**Subject: Walnut Creek Energy Park - Docket No. 05-AFC-2C  
Petition for Modification #5 - Cooling Tower Modification**

**Cooling Tower Modification**

**Walnut Creek Energy Park**

# REVISED COOLING TOWER MODELING ASSESSMENT

**Table 1-1 AERMOD Modeling Results**

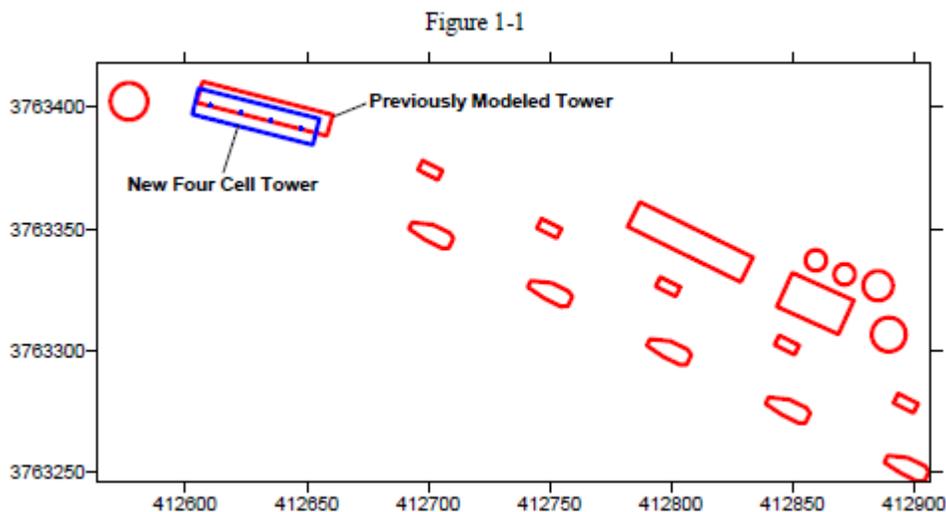
Additionally, to directly compare the previous dispersion modeling analyses with the revised assessment, the previous ISCST3 modeling input files were converted into an AERMOD format and rerun. Also indicated by the AERMOD outputs, the combustion emission sources (turbines and fire pump) will not be affected by the new cooling tower size or placement. For particulate matter emissions directly emitted by the cooling tower, the AERMOD modeling results demonstrate that there will be a slight decrease in modeled concentrations. Table 1-1 summarizes maximum-modeled concentrations for PM<sub>10/2.5</sub> as well as 1-hour NO<sub>2</sub>.

As a surrogate for the cooling tower HAP emissions, the annual PM<sub>10/2.5</sub> modeling results demonstrate a slight decrease in overall annual impacts. Based on the revised cooling tower modeling results and that the HAP emissions remain essentially unchanged, it would be expected that the annual HAP impacts would also slightly decrease. For the 1-hour acute impacts from HAP emissions, a normalized emission rate of 1 gram/sec was run for both the previously permitted cooling tower and the new proposed tower. The results, summarized in Table 1-1 clearly demonstrate that the acute impacts from the proposed cooling tower would be lower than the permitted cooling tower. Thus, the revised towers overall impacts for public health would be reduced.

All other pollutants and averaging times would have no changes in the magnitude or location of modeled impact. The following Table 1-1 and Figure 1-1 are excerpted from Attachment 1.

**Figure 1-1 Updated Building and Cooling Tower Location Map**

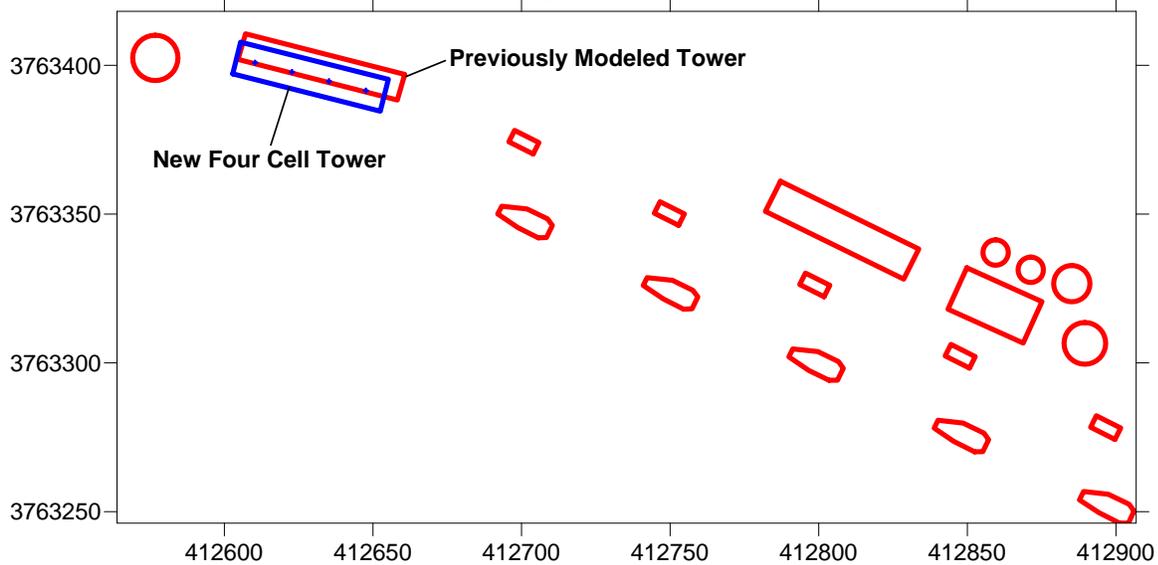
For modeling the potential impact of the revised cooling tower, the USEPA guideline model AERMOD (version 11103) was used following SCAQMD Modeling Guidance Procedures. These procedures are summarized below and include three years of SCAQMD processed meteorology. The revisions to the cooling tower location as well as revisions to the administration building and water storage tanks (highlighted in red) are presented in Figure 1-1.

The proposed four (4) cell cooling tower will also incorporate the following revisions:

- TDS at 4,850 ppm
- Water circulation rate at 36,500 gpm
- Cycles of concentration at 7.9
- Exhaust flow rate per cell at 952,058 ACFM
- Exit diameter is 28 feet
- Deck height at 42 feet and cone height (release height) at 48 feet
- Exit dry bulb temperature is 109 degrees F (worst-case summer temperature)
- PM10/2.5 emissions at 0.442 lb/hr (entire cooling tower) which is slightly less than the previous tower's emission rate of 0.444 lb/hr
- A slight decrease in the quantity of hazardous air pollutants
